CONTRACT CHANGE ORDER

CCO No. 28	Suppl. No.	Contract No. 76108/4076	Project Silver Springs Parkway Offsite (South Segment)	Federal Number(s) NA
----------------------	------------	-----------------------------------	--	--------------------------------

SILVER SPRINGS PARKWAY
(SOUTH SEGMENT)

SHEET
EX-2
2 of 4
P&T 76108

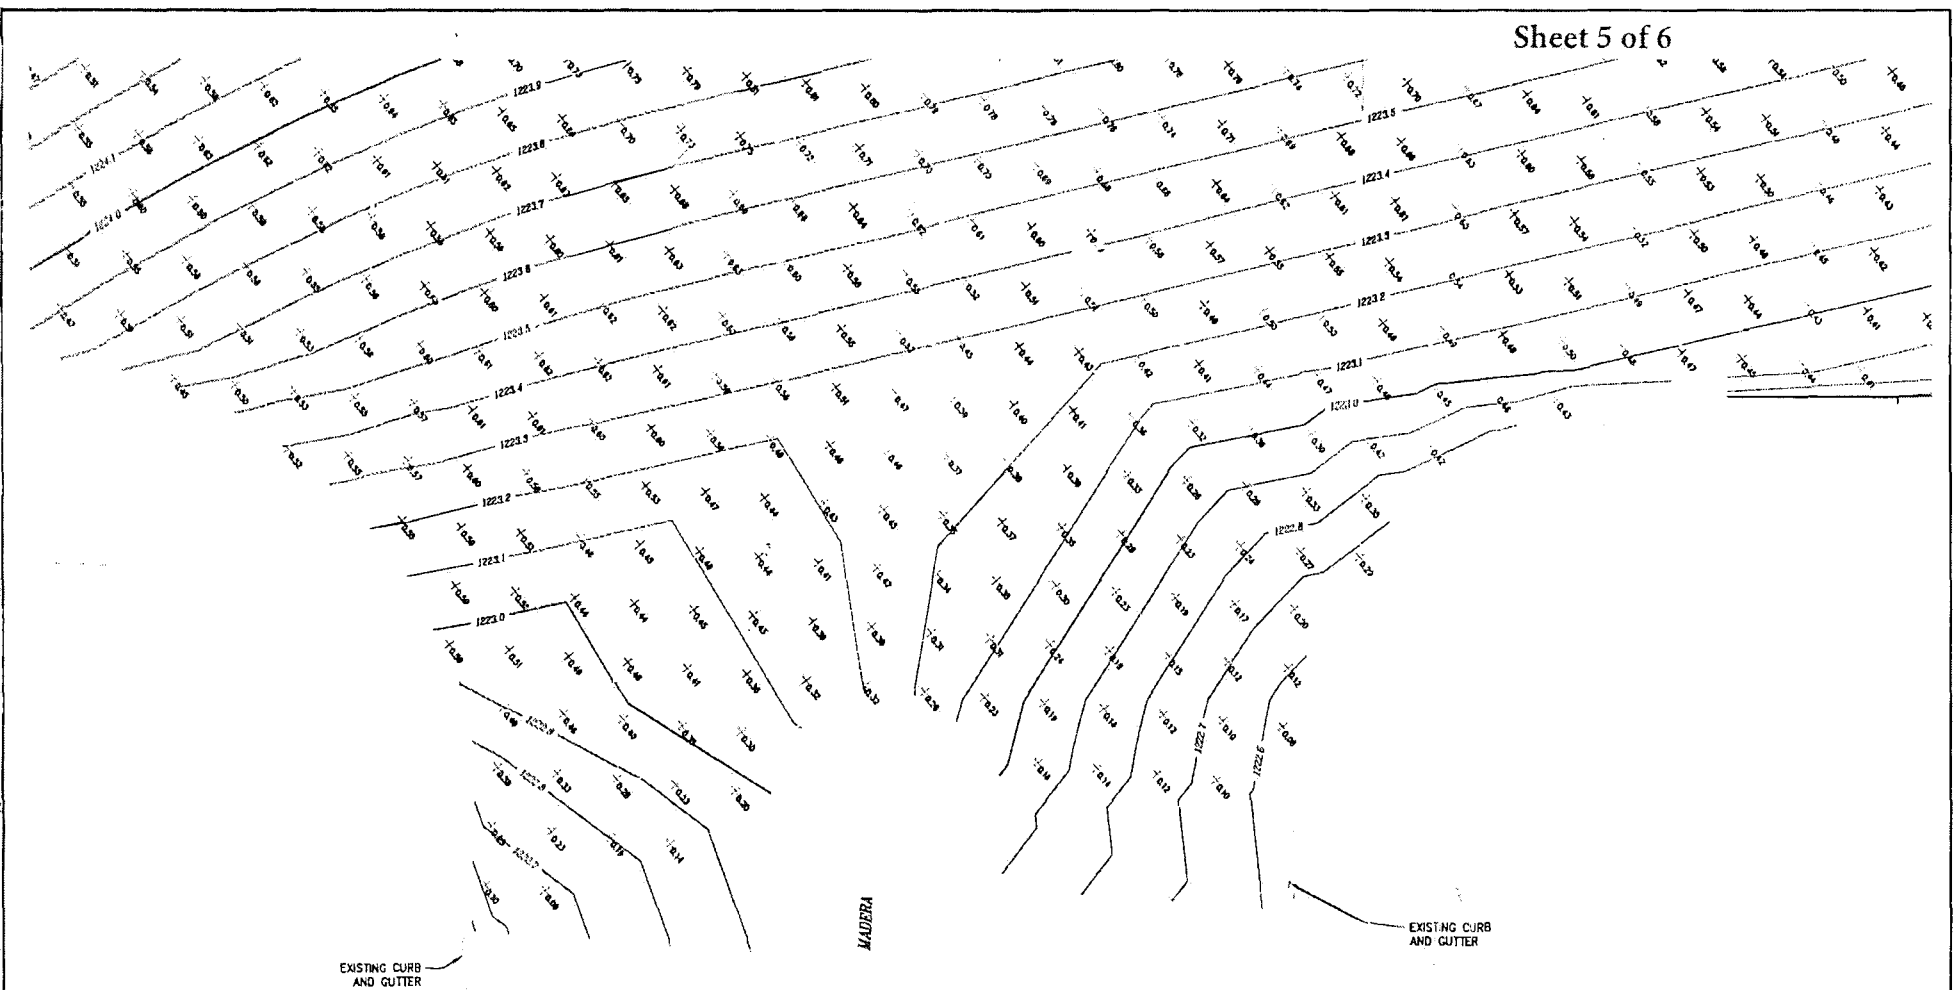
In accordance with Section 9-1.04, "Force Account," of the Standard Specifications, furnish necessary materials, equipment, labor, and construct a lift of hot mix asphalt (HMA) leveling course to switch public traffic safely back to Bass Lake Road. Perform the directed leveling course between "A" Line Station 124+60 and Station 131+60, and Madera Way between Bass Lake Road and Jasmine Circle/Summer Drive as shown on the exhibits, and as directed by the Engineer in such a way that the final product will bring new and the existing roadway grade at the same level for the traffic safety. Prior to the HMA leveling course, you must perform confirm grinding at Madera Way and Bass Lake Road, along the PG&E trench between "A" Line Station 126+47 to Station 128+27, and grinding depicted in the contract document. You must haul away and dispose of the ground HMA at an authorized disposal/recycling location, and stripe the traffic lanes, and install shoulder backing prior to Bass Lake Road open to the public traffic.
